Details about the data and experiments, and answers to your questions

Fig1 Topography height in the physical model and the location of WGs.

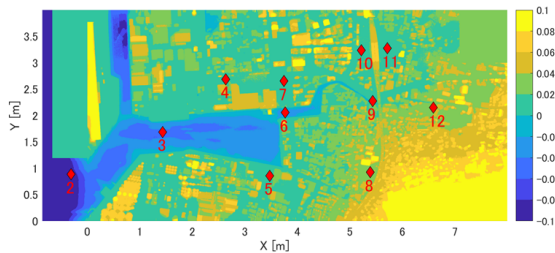
4. **Wave gage data at WG1 and WG2, and any other wave gages you might have had inside the model itself (harbor area) – I know the paper says there isn't any**

→ I send wave gauge data at WG1 and WG2. As described above, we can share the wave height data in the physical model in another wave condition.

Fig2 Example of estimated inundation extent and velocity at the water surface

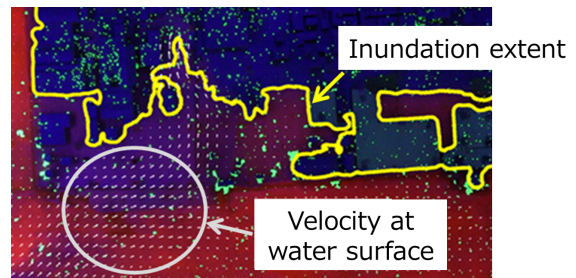
5. **Any velocity data (OK if there is none)**

→ As described above, we can share the velocity data estimated by the PIV analysis in the case of inundation experiments. (not debris experiments)
